Technical Note TN.JS-012

11 February 2013

Trailer Modification for 21m Wing Tips

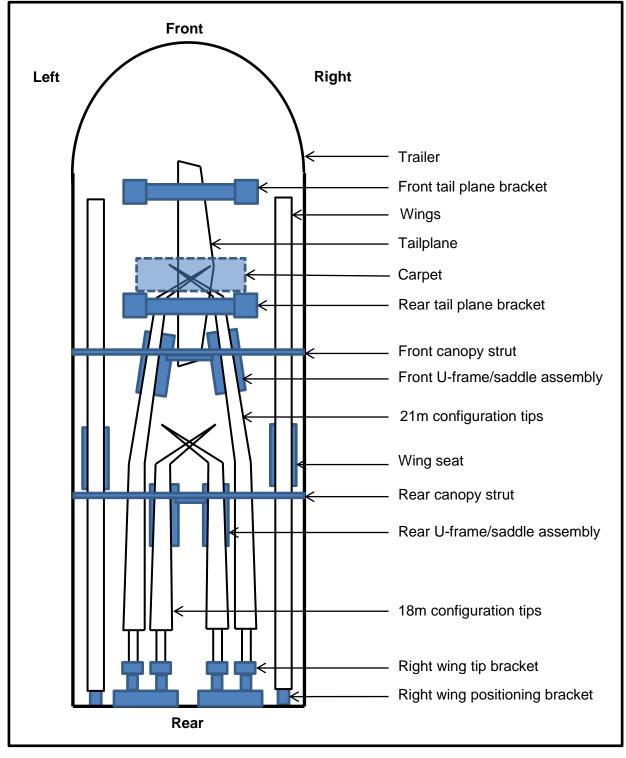
Figure 1 shows a schematic of the trailer with all the modifications completed. It also illustrates reference sides i.e. left, right, rear and front.

- New wing tip brackets at the rear to hold the wing tips at their roots.
- Narrower rear U-frame/saddle assembly to support the 18m tips.
- New front U-frame/saddle assembly to support the 21m tips.
- Modified rear tailplane bracket and new tailplane bracket spacer.
- New wing positioning brackets and relocated wing seats.

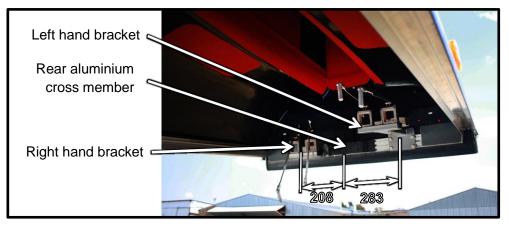
The wing tip brackets will secure the wing tips' roots. See Figure 2.

- 1.1. Remove the bolts retaining the current brackets, and then remove the brackets.
- 1.2. Bolt the new brackets in the positions as illustrated in Figure 2. (Dimensions in Figure 2 use the centre of the rear cross member as datum.)

Figure 3

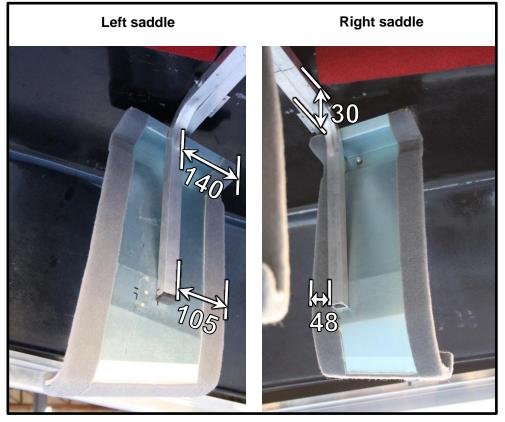
A narrower U-frame is required, which will bring the 18m wing tips closer to one another in order to prevent interference with the other glider parts.

- 2.4. Fitting the U-frame/saddle assembly in position.
 - 2.4.1. Align the U-frame/saddle assembly to the centre position of the canopy strut.
 - 2.4.2. Drill two holes in the strut and U-frame and bolt the assembly to the canopy strut's rear face. (Figure 3)

Figure 5

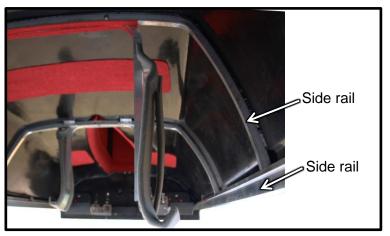
- 3. Installing the front strut and the U-frame/saddle assembly The U-frame and saddles mentioned in this modification is used to secure the 21m wing tips.
 - 3.1. Install the canopy strut 2440mm from the rear aluminium cross member. (see Figure 2).
 - 3.1.1. Push the strut fully against the trailer canopy.
 - 3.1.2. Rivet strut to the side rail of the canopy.1 rivet on either side. (see Figure 6).
 - 3.1.3. Use a sealant glue to fill the gap between the trailer canopy and the canopy strut.
 - 3.2. Installing the U-frame/saddle assembly.
 - 3.2.1. Fit the U-frame/saddle assembly to the centre position of the strut.
 - 3.2.2. Drill two holes, as illustrated and bolt the U-frame to the strut's rear face.
 - 3.2.3. Fit the aluminium L- brackets as illustrated in Figure 5. Drill and rivet as illustrated.Take care not to drill through the outer skin of the canopy.

Figure 7

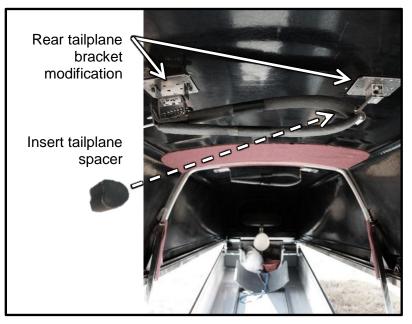
Spacers are inserted to lower the rear tailplane bracket. This will provide clearance between the tailplane and the 21 m tips.

- 4.2. Reinstalling the brackets with spacers as illustrated in Figure 7 Figure 10.
 - 4.2.1. Reinstalling the right hand side of the tailplane bracket as illustrated step wise in Figure 8. Figure 9 illustrates the modification when complete.
 - 4.2.1.1. Drill and rivet (2 counter sink rivets) the spacer to the mounting plate.
 - 4.2.1.2. Rivet the spacer-mounting plate assembly to the trailer canopy. Use the same holes in which the mounting plate was initially fastened.
 - 4.2.1.3. Rivet (2 normal rivets) the tailplane bracket to the spacer/mounting plate assembly.

4.2.3. Glue the tailplane spacer in position with contact adhesive as illustrated in Figure 7.

Figure 11

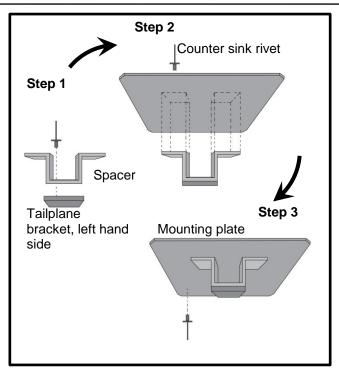
- 4.2.2. Reinstalling the left hand side of the tailplane bracket as illustrated step wise in Figure 10. Figure 11 illustrates the modification when complete.
 - 4.2.2.1. Drill and rivet(4 normal rivets) the spacer to the tailplane bracket.
 - 4.2.2.2. Rivet(4 counter sink rivets) the spacer/tailplane bracket assembly to the mounting plate.
 - 4.2.2.3. Rivet the mounting plate to the trailer canopy. Use the same holes in which the mounting plate was initially fastened. (Normal rivets)

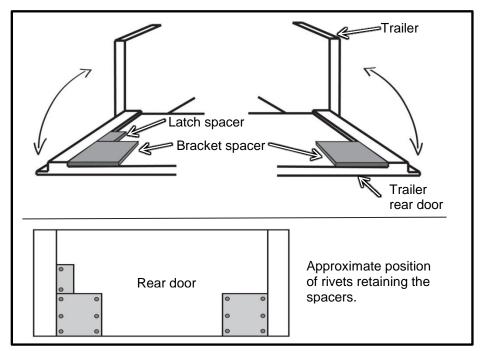
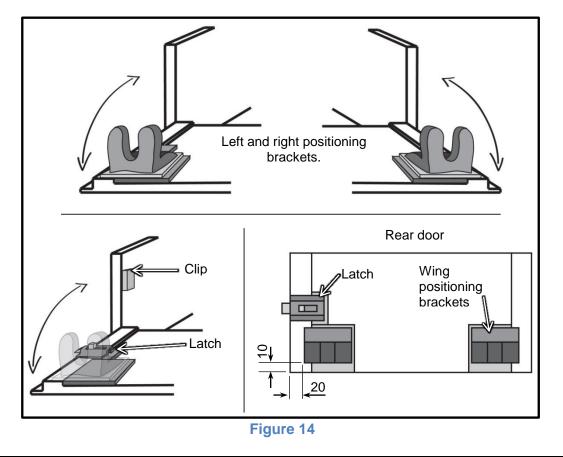
To ensure that the wing seats and the positioning brackets line up, the positioning brackets have to move as well. Figure 13 and Figure 14 provides illustrations on this modification.

- 6.1. Remove the brackets. (left and right)
- 6.2. Remove the latch.
- 6.3. Fit the spacers as illustrated in Figure 13. Neatly cut a bit of the rubber lining away for the spacers to fit. Drill the necessary holes and rivet only the wing positioning bracket spacers to the door. Use Figure 13 as a guideline. Be sure to make a counter sink recess where the holes are drilled in the spacers and use countersink rivets for fastening. Keep in mind that the brackets and latch has to be riveted to the spacers.

- 6.4. Fit the new brackets in the new position on top of the spacers- 10mm from top and 20mm from side. (Figure 14)
- 6.5. Drill the necessary holes and rivet to secure the brackets. (Normal rivets can be used)

- 6.7. Find a new position for the latch mechanism. (Just below the positioning bracket should be adequate)
- 6.8. It is also necessary to move the latch's clip to a new position so that the latch has something to clip into. (Figure 14)

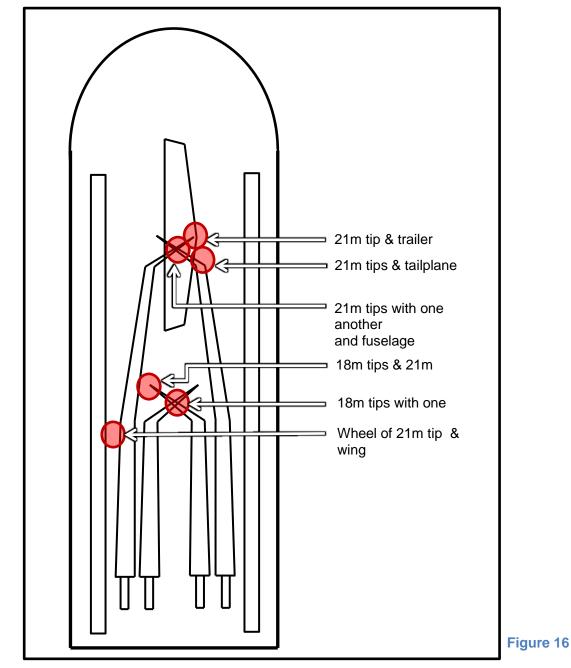
- 8.1. Before closing the canopy of the trailer, the following areas should be checked for interference, preferably with the aid of an assistant inside the trailer:
 - 8.1.1. the wing tips with one another,
 - 8.1.2. the wing tips and the roof,
 - 8.1.3. the wing tips and the fuselage,
 - 8.1.4. the 21m wing tips and the tailplane and
 - 8.1.5. the 21m wing tip wheels and wings.
